MODEL: CT-F4242, CT-F4040

SUBJECT: Change of motor and circuit modification.

REASON: To improve REW→STOP operation.

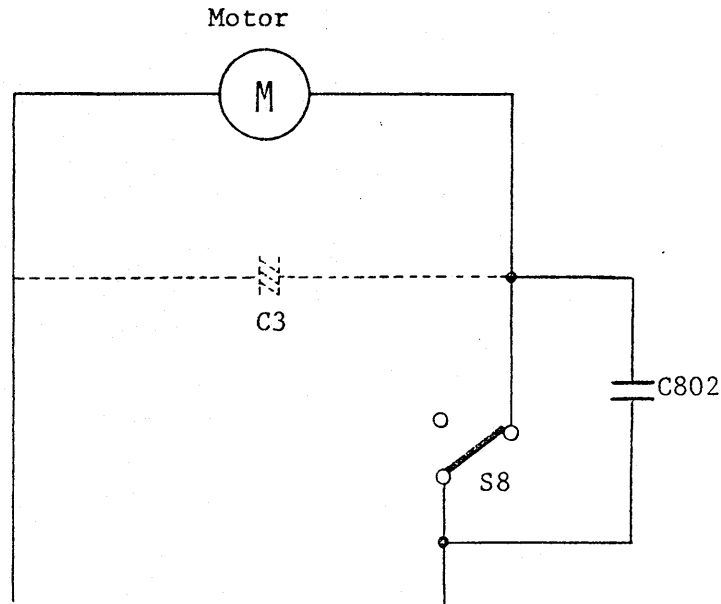
(Old)		(New)
Motor	RXM-027	→	RXM-038
Capacitor	C3 : 2200μF 16V	→	Deleted
	CEA222P16

NOTICE: Old and new motors are interchangeable.  
But remove the capacitor (C3) when you replace the motor with new one because Motor has been modified to make turque up.
